Re: Deer Haven Subdivision

Permit No.: 4908-WR-2; AFIN: 04-01681

Following are answers to the "Deficiencies" listed in your letter to Mr. Charles B. Cook dated Aug. 11, 2017.

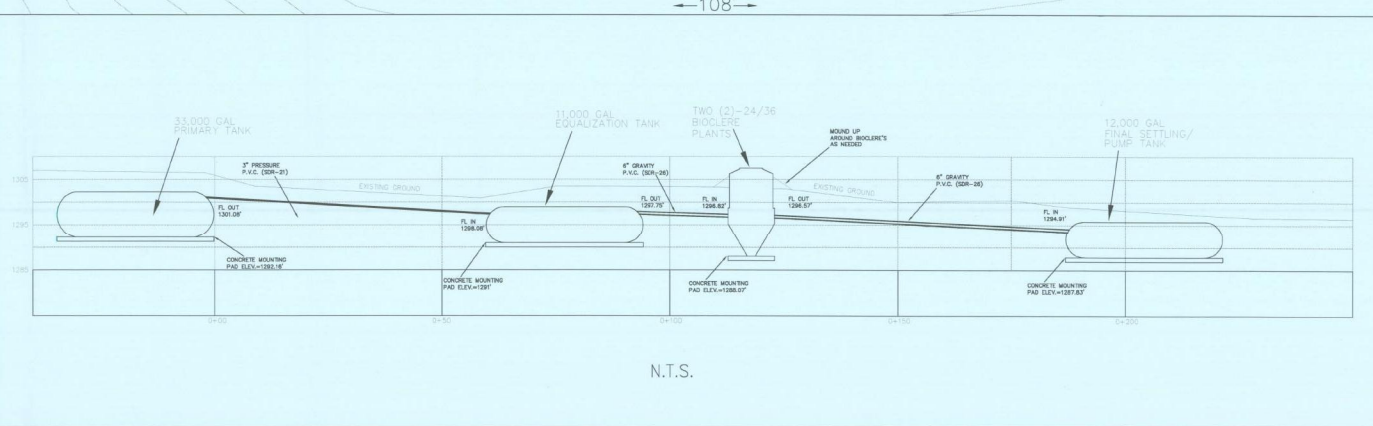
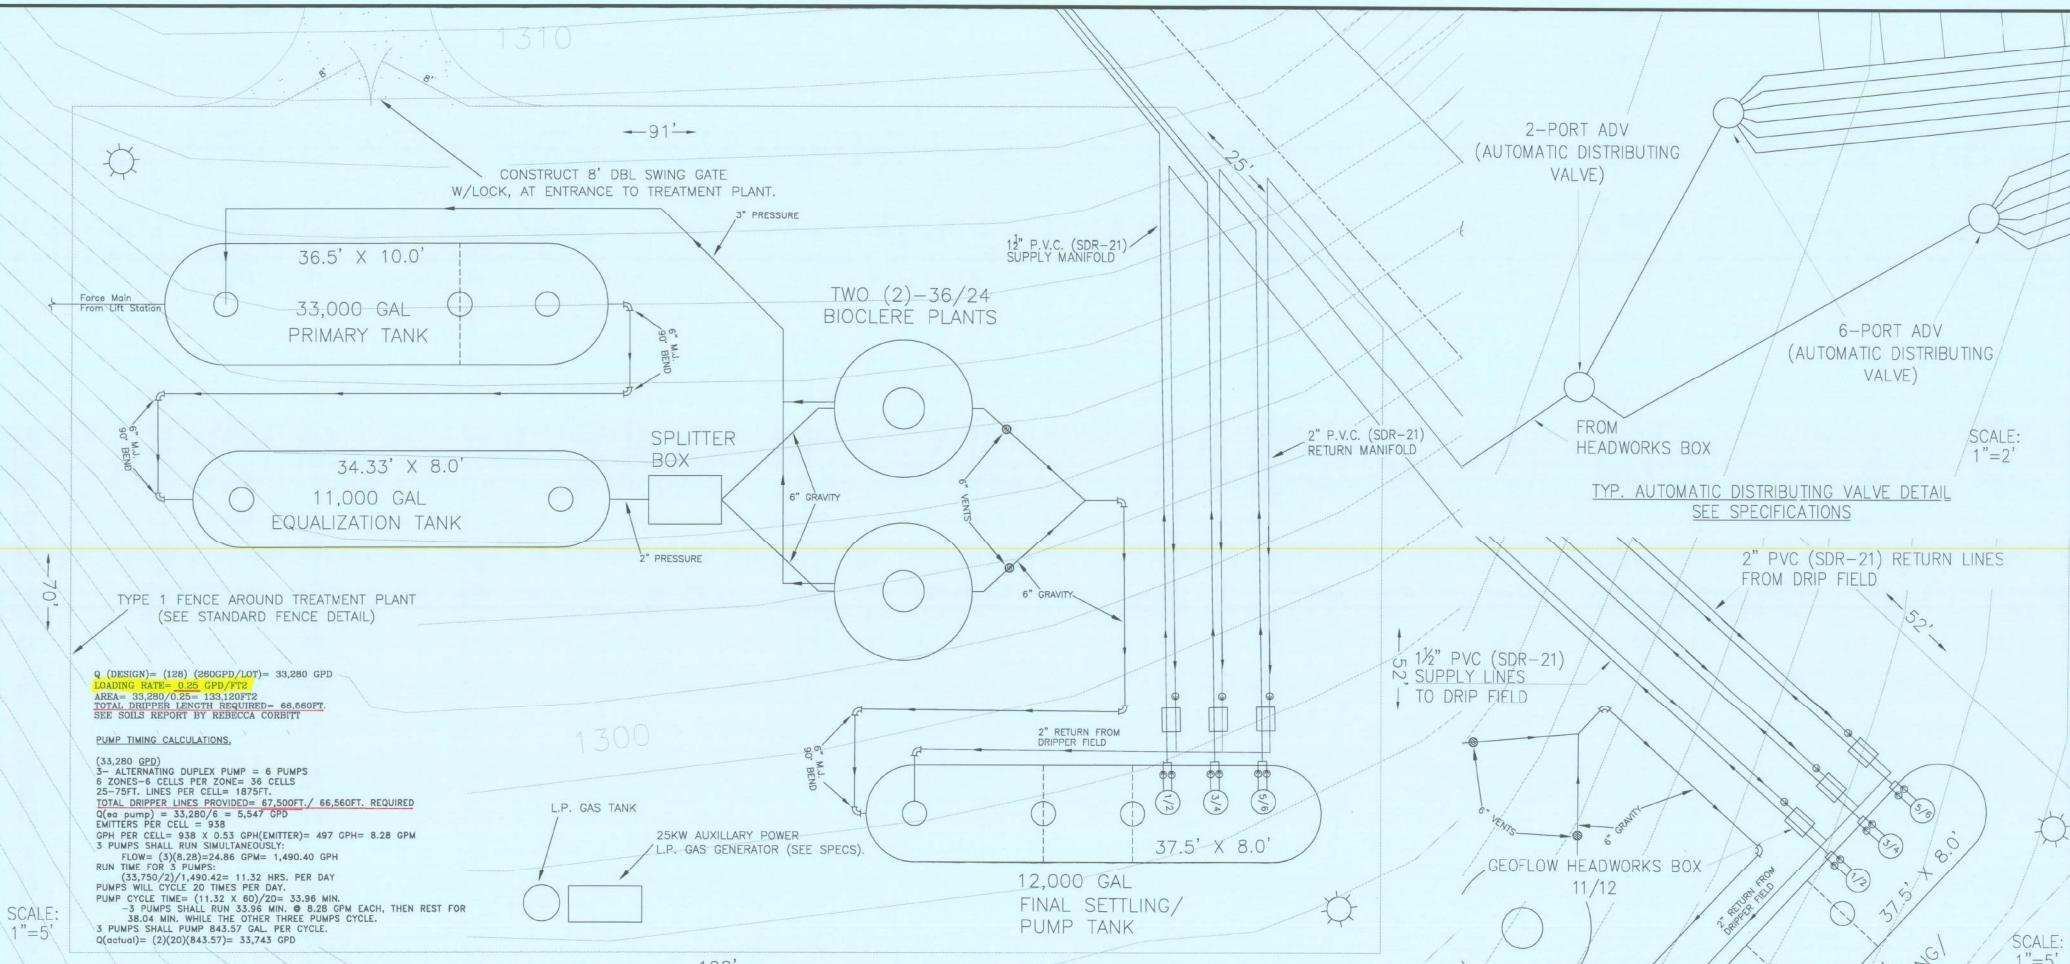
- 1.) There are nineteen (19) homes currently connected to the drip irrigation system.
- 2.) See the enclosed set of plans for:
 - a.) the drip zones.
 - b.) the area of each drip zone.
 - c.) the location of each soil test pit with the loading rate written in red.

TREATMENT PLANT LAYOUT
 for
 DEER HAVEN SUBDIVISION
 for
 FRANKLIN MILLER
 TO THE COUNTY OF
 BENTON, ARKANSAS

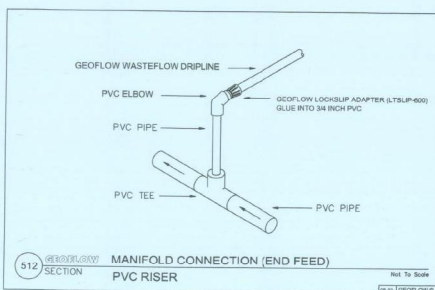
** All 6 Zones are loaded the same, see sheet #3 of the plans.*
